Re: Trans Mountain Pipeline ULC

Chilliwack BC Hydro Route Realignment

We write to provide comments regarding Trans Mountain Pipeline route realignment request made pursuant to section 21 of the *National Energy Board Act*.

CAPTURE ZONES FOR CITY OF CHILLIWACK PUMPING WELLS **OPERATING AT PROJECTED DEMANDS**

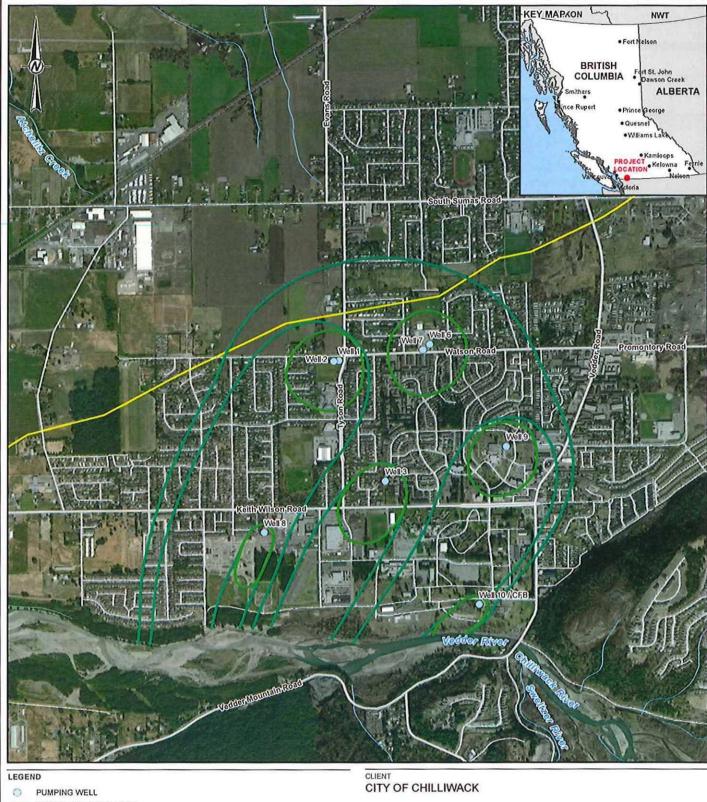
As summarized in our July 17th letter to the NEB, we have community drinking water wells 225m and 230m from the existing pipeline. These distances would be widened to 275m and 365m respectively from the proposed pipeline along the BC Hydro transmission right-of-way.

This extra distance is important. Historically, we have studied the aquifer response to water well operation, and we are currently updating our aquifer study. The firm of Golder & Associates is currently completing the Sardis-Vedder Aquifer Groundwater Model Update Study. The preliminary study results indicate that well pumping influences the ground water table to a distance of 450m from the well head. This finding confirms the importance of the physical separation between potable water wells and petroleum pipelines. See Golder & Associates Figure 1, attached, from the study.

In short, the BC Hydro Transmission right-of-way route contemplates wider physical separation between the wells and the pipeline than the proposed Realignment. Therefore, the City of Chilliwack prefers the current Trans Mountain Pipeline alignment, within the BC Hydro transmission right of way.
